05.2-07

TECHNICAL BULLETIN

Poor Drivability/MIL Illumination –
Check Throttle Synchronization

MODEL	1995 MY XJ12 Sedan
VIN	720001-ON

ILLUSTRATION 1

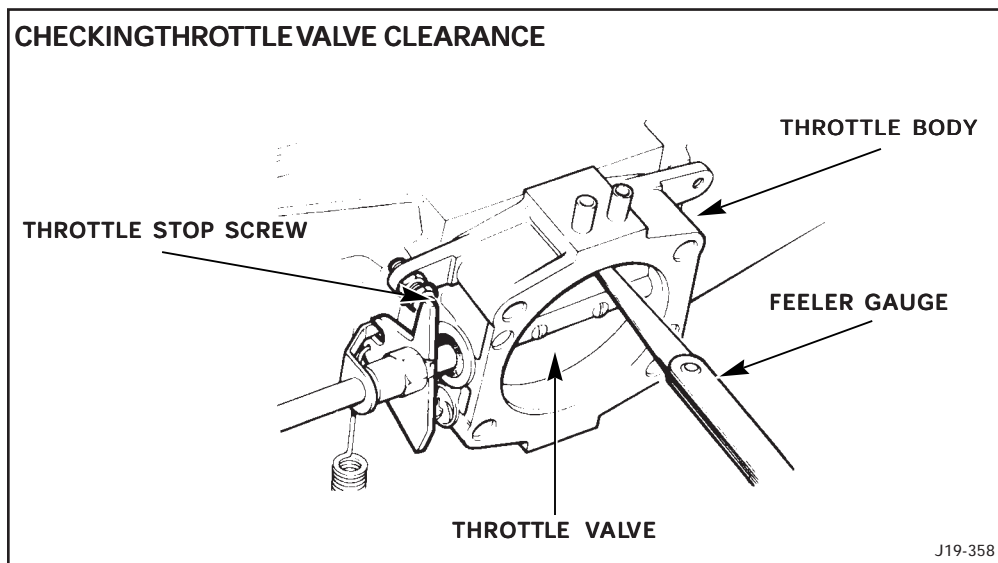
1. Check that both throttle valves are centered horizontally and vertically in the throttle bodies.
2. With the throttle valve closed, use a feeler gauge to check the clearance between the throttle valve and the throttle body (Illustration 1).

Check the clearance at the bottom as well as at the top of the throttle valve. If a significant difference is found between the top and bottom measurements, the throttle valve may be offset on its shaft. If both measurements are within the above range, do NOT adjust the throttle stop screw (Illustration 1).

Throttle valve checking clearance: 0.001 - 0.003 inch (0.025 - 0.076 mm)

3. If adjustment is necessary, set the throttle stop screw to achieve the following throttle valve clearance range:

Throttle valve setting clearance: 0.001 - 0.0015 inch (0.025 - 0.04 mm).

ILLUSTRATION 2

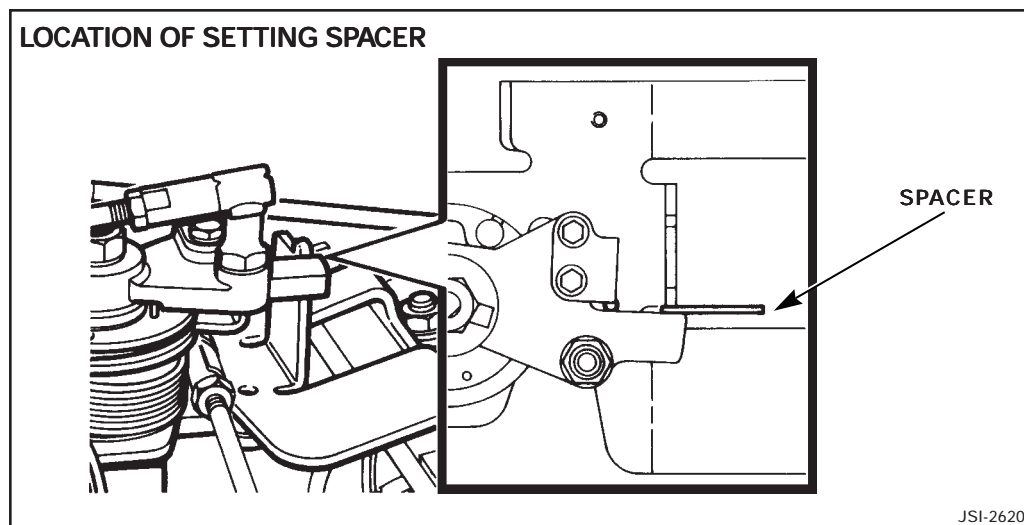
1. Loosen both locknuts on the two linkage rods between the center throttle turntable and the throttle levers.
2. Disconnect one linkage rod from its ball pin on the linkage rod bracket.
3. Position a 0.079 inch (2.00 mm) spacer between the linkage rod bracket and its stop (Illustration 2).

4. Turn the linkage rod that is still connected to increase its length until the throttle lever clears its stop screw.
5. Shorten the linkage rod until the throttle lever just touches its stop screw. Tighten both lock nuts on the linkage rod.

8. Check the backlash by turning the linkage rod bracket of the throttle turntable slightly clockwise. A gap should appear between the bracket and its stop before either throttle lever leaves its stop screw.
Gap dimension: 0.062 - 0.094 inch (1.57 - 2.39 mm)

9. Both throttle levers should leave their stops at the same time. Satisfactory synchronization is possible if the second throttle lever moves from its stop after the first throttle lever within a maximum additional increase of 0.030 inch (0.76 mm) in the gap.
